LARAMIE COUNTY PLANNING & DEVELOPMENT DEPARTMENT

TITLE: PUBLIC HEARING regarding a Subdivision Permit & Plat for Bison Crossing, 11th Filing, situated in the SW¼ of Section 30 and the NW¼ of Section 31, Township 13N, Range 66W of the 6th P.M., Laramie County, WY.

RE: BISON CROSSING 11TH FILING – FINAL PLAT & SUBDIVISION PERMIT TRANSMITTAL NARRATIVE

RE: BISON CROSSING 11TH – RESPONSE TO PLAT COMMENTS – PZ-24-00002

FINAL PLAT FOR BISON CROSSING, ELEVENTH FILING

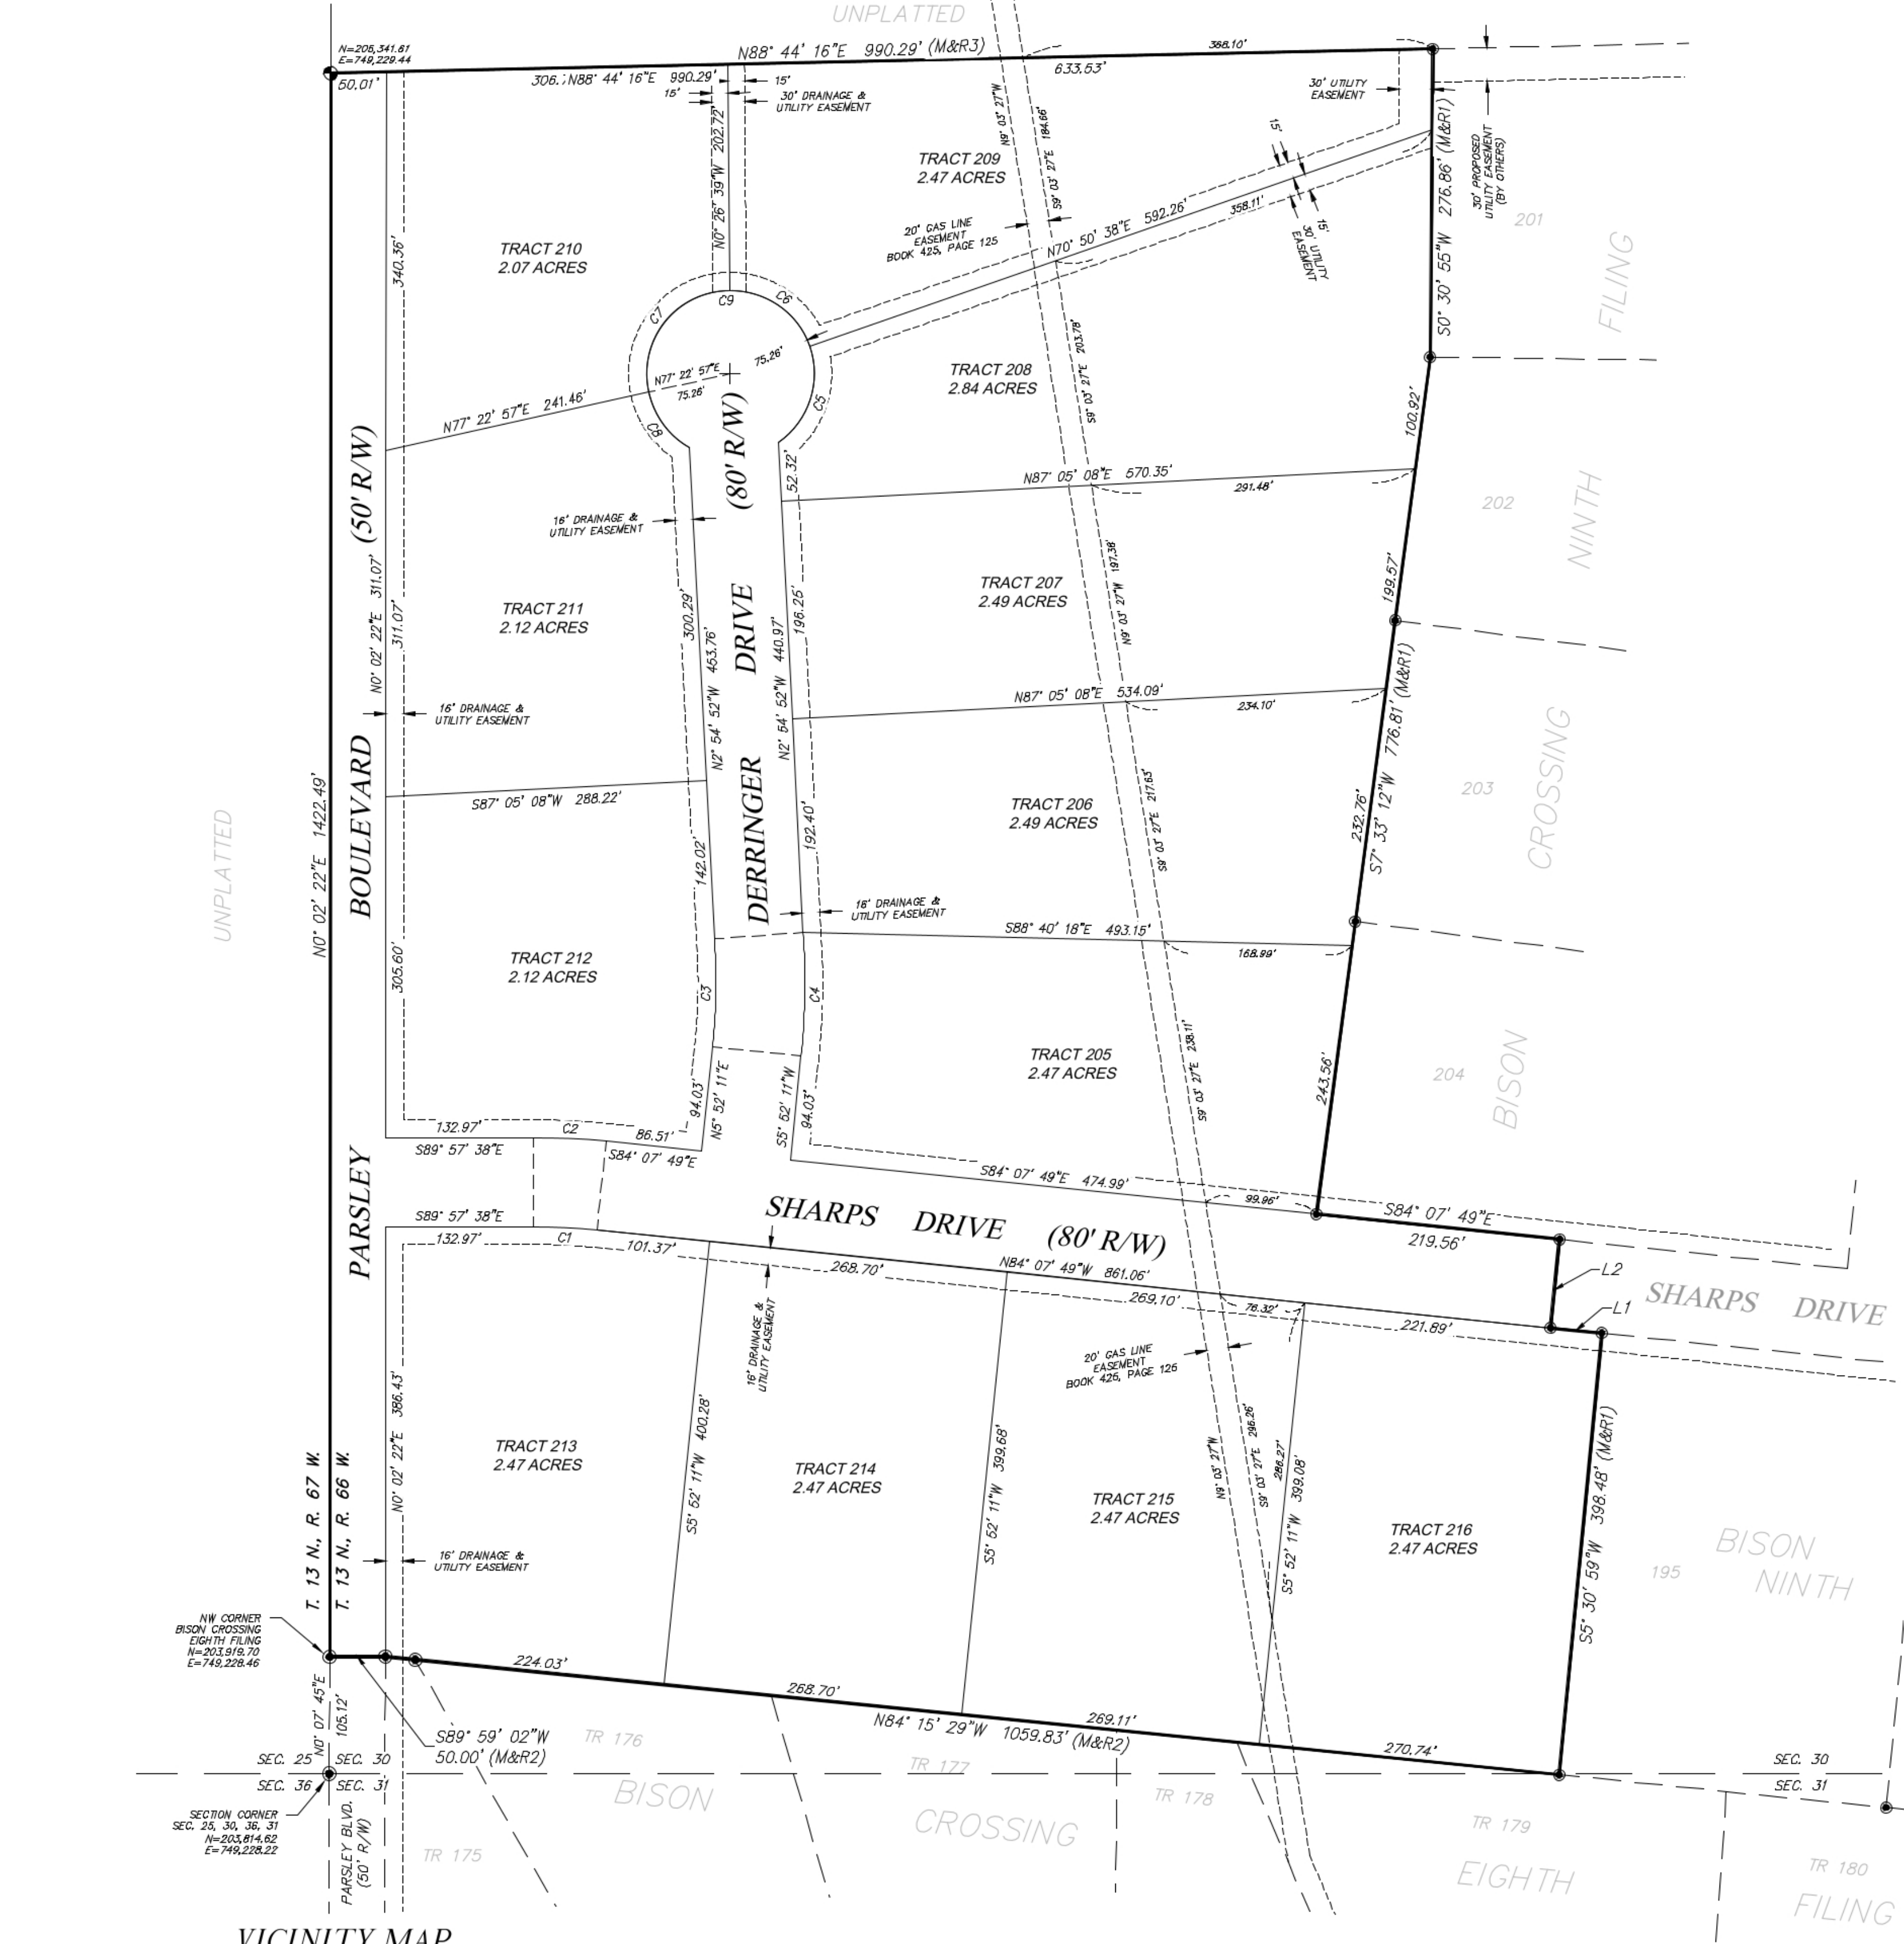
1. Parsley Blvd is a Minor Arterial on the Master Street Plan Official Map 2023. The portion of Parsley Blvd designated as 50 feet of Future Parsley Blvd. Easement shall be dedicated as 50 feet Parsley Blvd. Right-of-Way with 16 feet utility easement adjacent to the Right-of-Way.

1. A note shall be added to the plat indicating "there will be no public maintenance of internal roadways/access easements."
2. All roadways shall be designed and constructed to LCLUR, and the design plans shall be submitted to the County for review and approval.
3. Provide a name for "Proposed Road".
4. please dedicate the right-of-way for Parsley Blvd instead of an easement.
5. At time of review by Public Works, the review engineer comments had not been submitted. If the comments need further conversation and/or clarification, please do not hesitate to reach out to Public Works.
6. A note shall be added to the plat indicating "All Tracts are to be accessed off internal roadways/access easements."

1. The Drainage Report submitted adequately addresses the drainage characteristics for the subdivision at this stage. As indicated in the report, a Final Drainage Report will be submitted with the construction plans.
2. I concur there is no need for a detailed Traffic Study.
3. The year under the Acknowledgments needs to be changed from 2023 to 2024.

1. The difference between the 2 radii of CURVE C3 and CURVE C4 doesn't seem to make sense. As indicated in the CURVE TABLE the difference would be 95.65 and the street is labeled as an 80 R/W.
2. There appears to be an easement falling east of and adjacent to the northeast corner of TRACT 209, that should be labeled with purpose and width.
3. The Vicinity Map would be more congruent with the Title Block requirements if one were to add information such as, at a minimum, the Section, Township and Range data with enough detail to indicate the location of the subdivision within the Section.

Addressed.

Addressed and noted.

Addressed. See revised plat.
